**COMMENTS OF THE STAFF OF THE CALIFORNIA
PUBLIC UTILITIES COMMISSION
REGARDING THE 2018-2019 TRANSMISSION PLANNING PROCESS
PRELIMINARY POLICY AND ECONOMIC ASSESSMENT FOLLOWING THE
NOVEMBER 16, 2018 STAKEHOLDER MEETING**

November 30, 2018

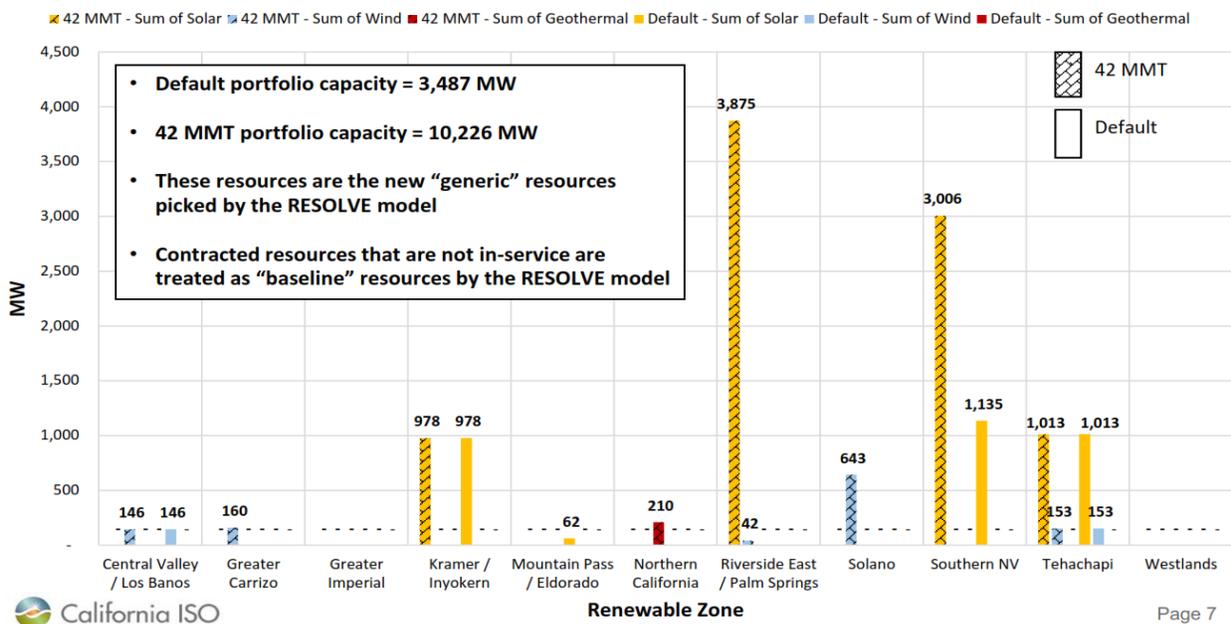
3. CPUC Staff would like to bring to CAISO’s attention that slide 18 contains an inaccurate statement regarding the portfolios provided by IRP to CAISO for TPP purposes.

The following slide title found on slide 18/312 is inaccurate, *“Default portfolio modeled in the year-10 TPP reliability case is a subset of the 42 MMT portfolio which includes FCDS and EODS resources.”* The

Default portfolio is not necessarily a subset of the 42 MMT portfolio. Although the 42 MMT portfolio does reduce GHG emissions beyond the emission reductions resulting from the Default (50% RPS), the 42 MMT portfolio does not start with the resources selected under the Default portfolio and build on that with incremental resources. Instead, it starts from scratch and includes resources that best meet numerous constraints. For this reason, in a few renewable zones, the amount of certain generic resource types decreases when moving from the Default portfolio to the 42 MMT portfolio. For example, Mountain Pass/Eldorado contains 62 MW of new generic solar resources under the Default Scenarios but 0 MW under the 42 MMT Scenario. This is visible in the graph contained on that slide, included below for convenience.
